**Cumberland County Jail**  
**Existing Medical Upgrades – DRAFT PRICING**

# CLARIFICATIONS & QUALIFICATIONS

**PROJECT:** Cumberland County Jail Existing Medical Space Upgrades

**DATE:** 7/2/25

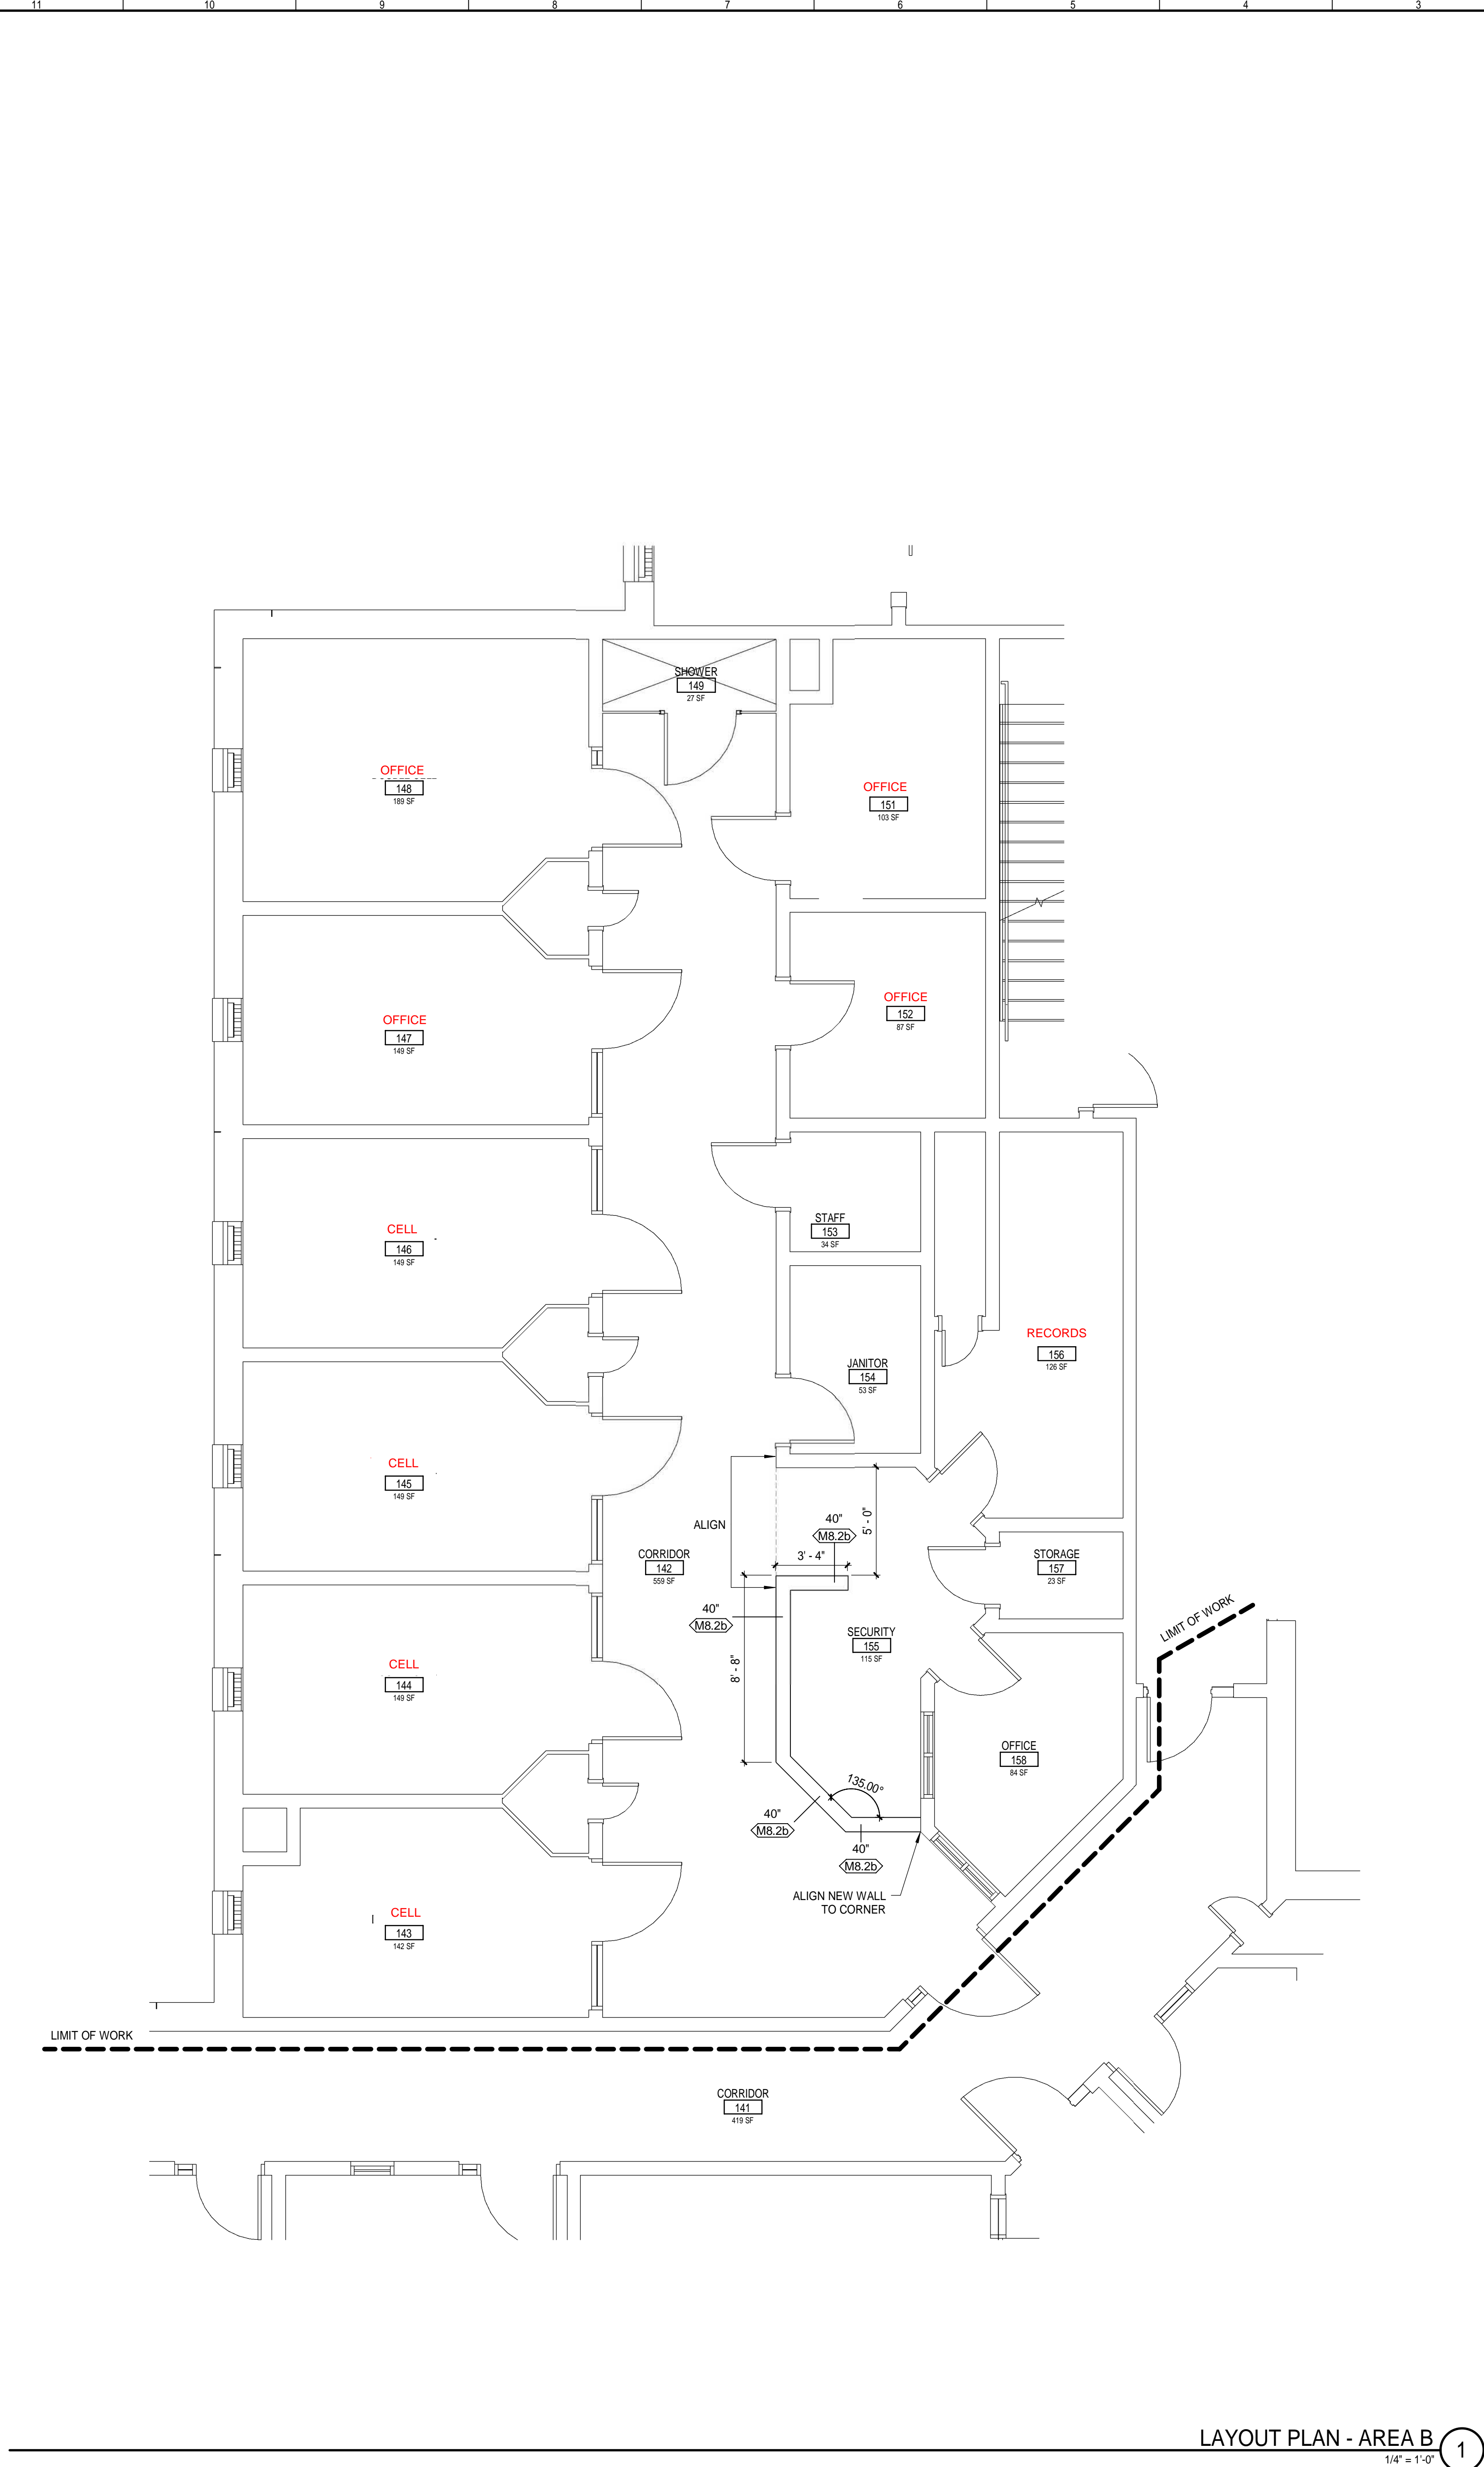
Retrofit locks to provide keyed access. ME to follow up

Provide Spec from manufacturer?

Kanescreen for the mesh

FINISH PLAN - AREA B A3  
1/4" = 1'-0"

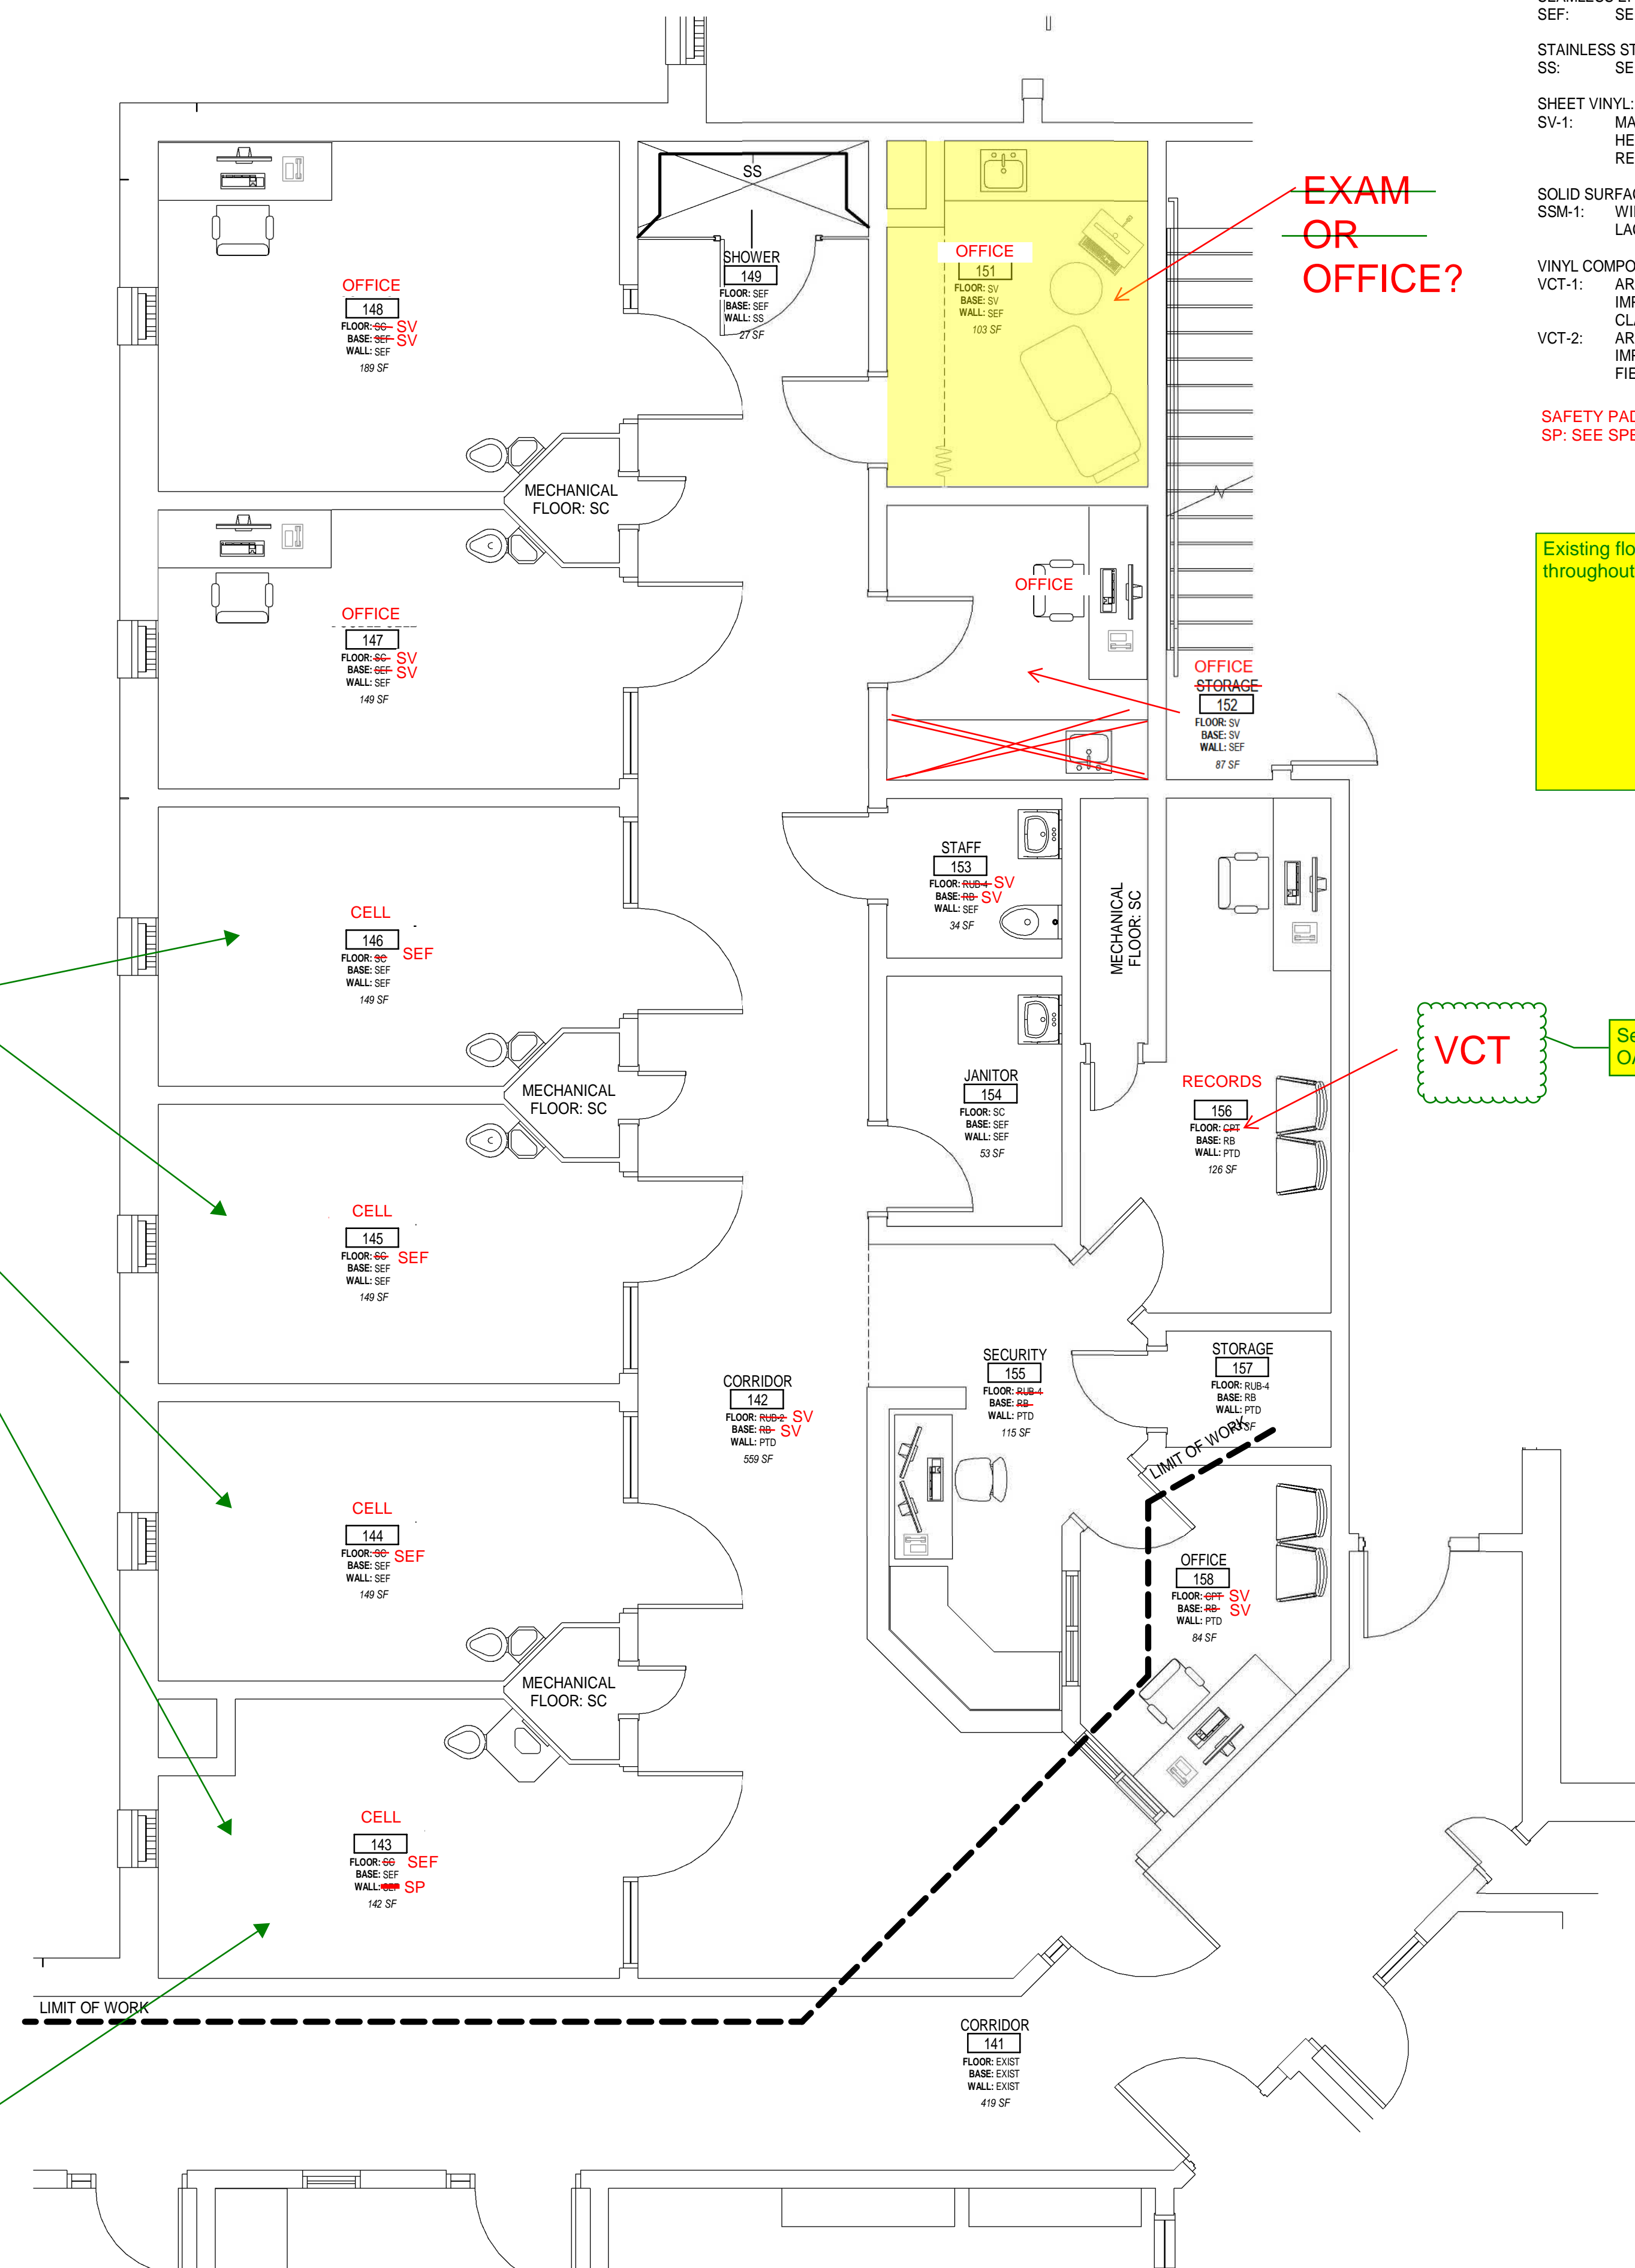
Sealed Concrete with  
caulk joint at  
floor/wall joint per  
OAC

ME to clarify extents  
of safety padding
